PARTS & SERVICE	REF NO.	AT02125A
NEWS	DATE	Apr. 11, 2003
		Page 1 of 3

- **SUBJECT:** MODIFICATION PROCEDURE OF MOUNTING METHOD OF RUBBER SPRING ON HM400-1, 350-1
- **PURPOSE:** To introduce modification procedure to prevent loosening of the mounting bolts for the rear suspension rubber spring on HM400-1 and HM350-1 articulated dump trucks
- APPLICATION: HM400-1 Articulated Dump Trucks, HM350-1 Articulated Dump Trucks, See next page.

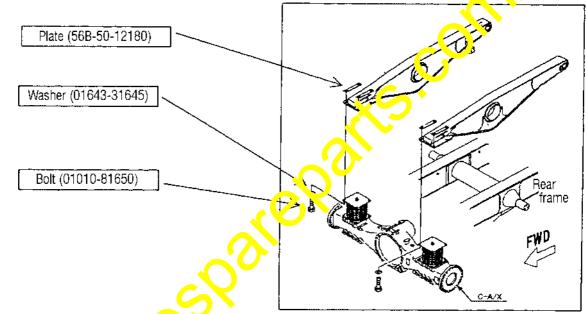
- 3. Contents of the modification
  - The change of the connection method between the center shaft rubber spring and the equalizer bar.

The connection method is to be changed from the current method which uses the lock plate (56B-50-12180) to the new method which uses the nut (01580-11613) + washer (01643-31645) to improve the structure to prevent loosening of the mounting bolts. ▲ 21T-54-16150

- 4. Preparations before starting the modification work
  - 1) Park the vehicle on a flat plate and apply chocks to the tires.
  - 2) Raise the dump body and insert the safety pins (on both of the LH and RH sides).
- 5. Modification procedure
  - 1) Remove the bolts (01010-81650), washers (01643-31645) and plates (56B-50-12180).

2) Connect the rubber spring and the equalizer bar using the bolts, washers and nuts. In the meantime, clean the connecting surfaces of the rubber spring and the equalizer bar to remove cil, paint, dust, etc.
